HFT Geometry Notes

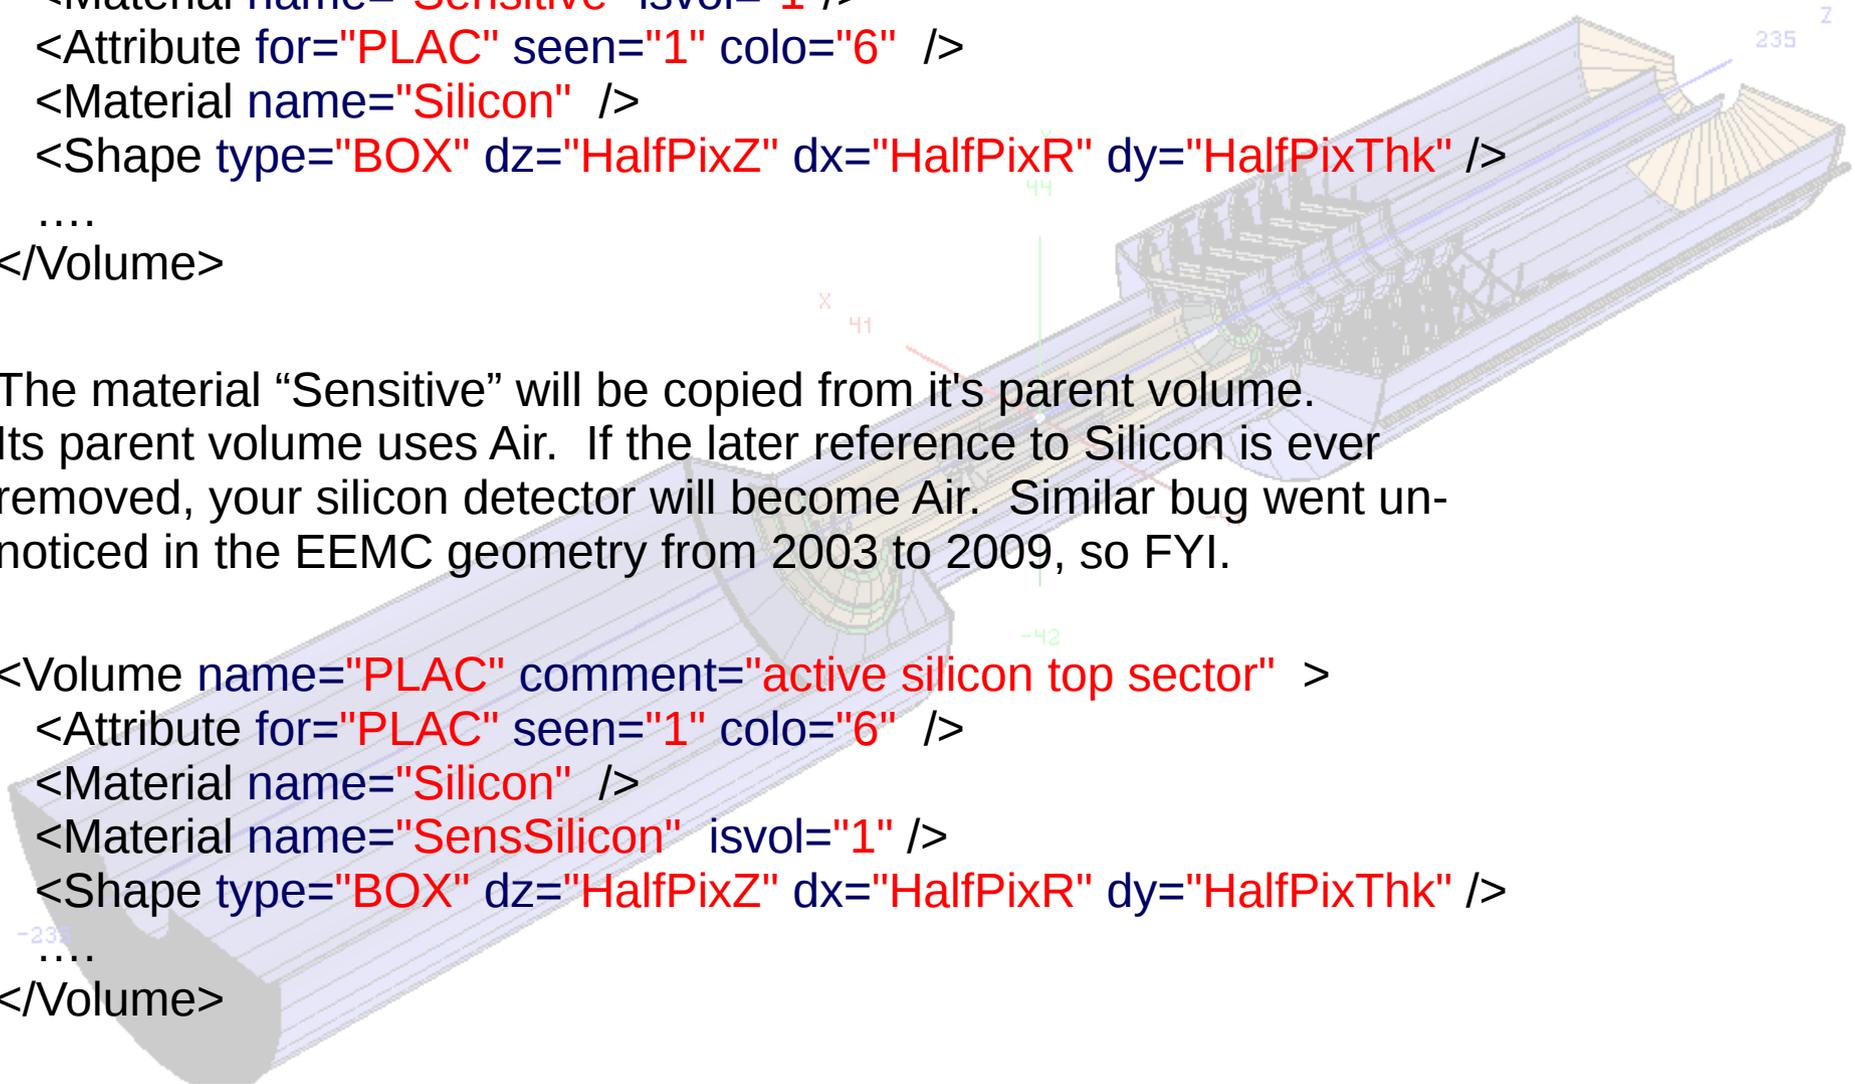
The material "Sensitive" will be copied from it's parent volume. Its parent volume uses Air. If the later reference to Silicon is ever removed, your silicon detector will become Air. Similar bug went unnoticed in the EEMC geometry from 2003 to 2009, so FYI.

<Volume name="PLAC" comment="active silicon top sector" >
  <Attribute for="PLAC" seen="1" colo="6" />
  <Material name="Silicon" />
  <Material name="SensSilicon" isvol="1" />
  <Shape type="BOX" dz="HalfPixZ" dx="HalfPixR" dy="HalfPixThk" />
  ....
</Volume>

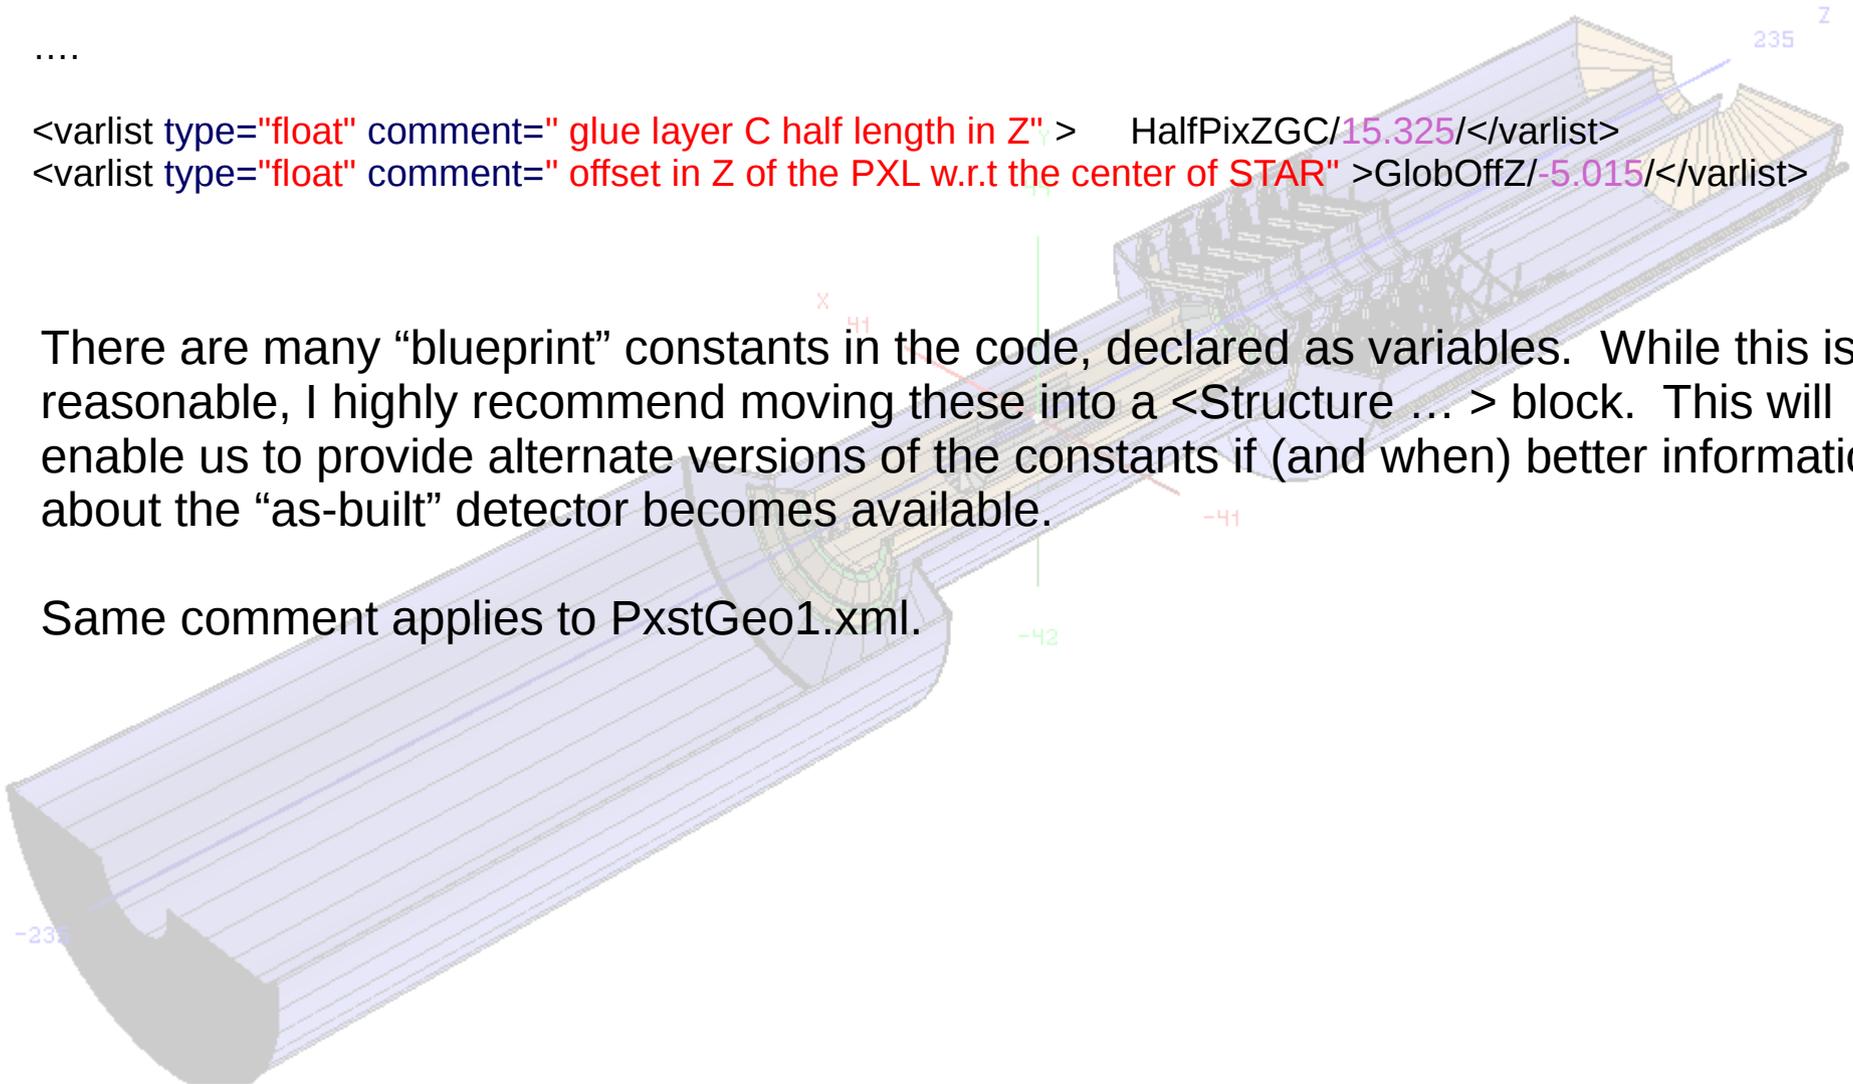
There are many “blueprint” constants in the code, declared as variables. While this is reasonable, I highly recommend moving these into a `<Structure ... >` block. This will enable us to provide alternate versions of the constants if (and when) better information about the “as-built” detector becomes available.

Same comment applies to PxstGeo1.xml.

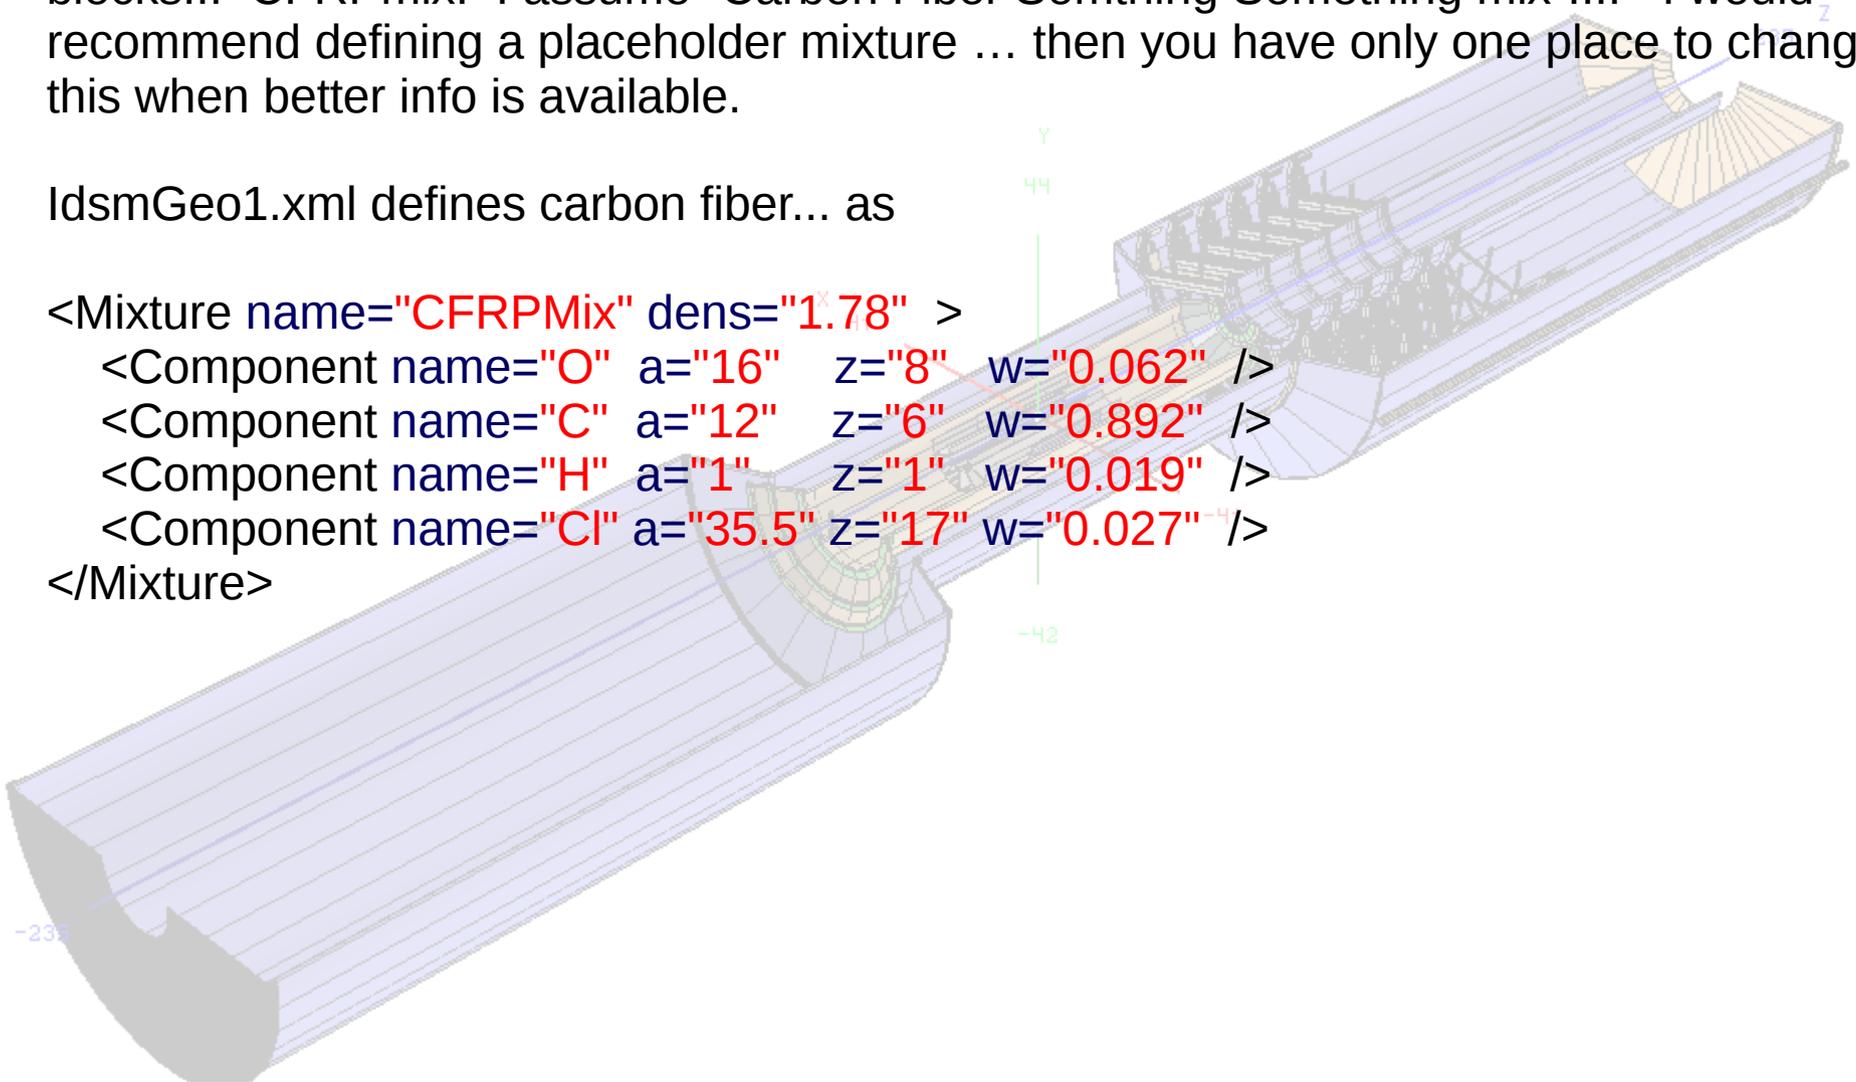
There are many-many-many instances of a single material being declared in several blocks... CFRPmix. I assume "Carbon Fiber Somthing Something mix".... I would recommend defining a placeholder mixture ... then you have only one place to change this when better info is available.

IdsmGeo1.xml defines carbon fiber... as

```
<Mixture name="CFRPMix" dens="1.78" >
  <Component name="O" a="16" z="8" w="0.062" />
  <Component name="C" a="12" z="6" w="0.892" />
  <Component name="H" a="1" z="1" w="0.019" />
  <Component name="Cl" a="35.5" z="17" w="0.027" />
</Mixture>
```
